Access Compliance Report

Public Rights-of-Way

Intersection ID: 18974	Main Street: RANDOLPH_RD	Cross Street: WILLHAVEN_DR	Location:	N
ADA ID: A1A3741446AB	Ramp Type: Perp	Initial Pass/Fail: Pass	Overall Compliance: No	Severity Score: 10
Codes/Mitigation Info/Possible Solution		Field Measurements/Component Compliance

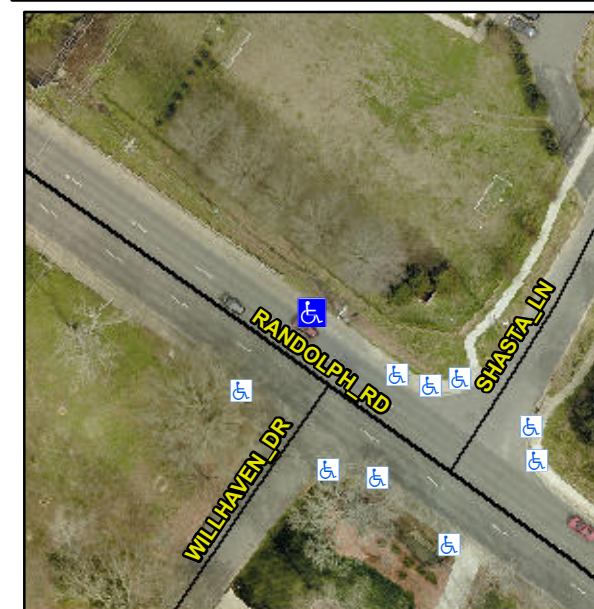
Not Found, R304.2.1, R304.2.2-Perp, R304.3.2-Para, R304.5.3

Compliance	Description	Data	Compliance	Description	Data
N/A	Ramp Length (in)	72.0	Yes	Ramp Slope (%)	7.0
Yes	Ramp Width (in)	48.0	Yes	Ramp XSlope (%)	0.5
N/A	Flare Type LT	Sloped	N/A	Flare Type RT	N/A
N/A	Flare Slope LT (%)	9.1	Yes	Flare Slope RT (%)	6.5
N/A	Flare Traversable LT?	Yes	N/A	Flare Traversable RT?	Yes
No	Landing Length (in)	N/A	Yes	DWS Provided?	Yes
No	Landing Width (in)	N/A	Yes	DWS Contrast?	Yes
No	Landing Slope (%)	N/A	Yes	DWS Length (in)	24.0
No	Landing X Slope (%)	N/A	Yes	DWS Full Width?	Yes
N/A	Landing Curb? (Y/N)	No	Yes	DWS Offset (in)	1.5
N/A	Shared Landing?	No			
Yes	Gutter Ponding?	No	Yes	Gutter Slope (%)	2.1
Yes	Gutter Lip Ht (in)	0.0	Yes	Gutter X Slope (%)	0.5
N/A	Painted X Walk1?	No	N/A	Painted X Walk2?	N/A
	X Walk 1 Direction	To SW		X Walk 2 Direction	N/A
N/A	X Walk 1 Width (in)	N/A	N/A	X Walk 2 Width (in)	N/A
	X Walk 1 Slope (%)	2.4		X Walk 2 Slope (%)	N/A
	X Walk 1 X Slope (%)	0.5		X Walk 2 X Slope (%)	N/A

Remove & Replace Entire Ramp.
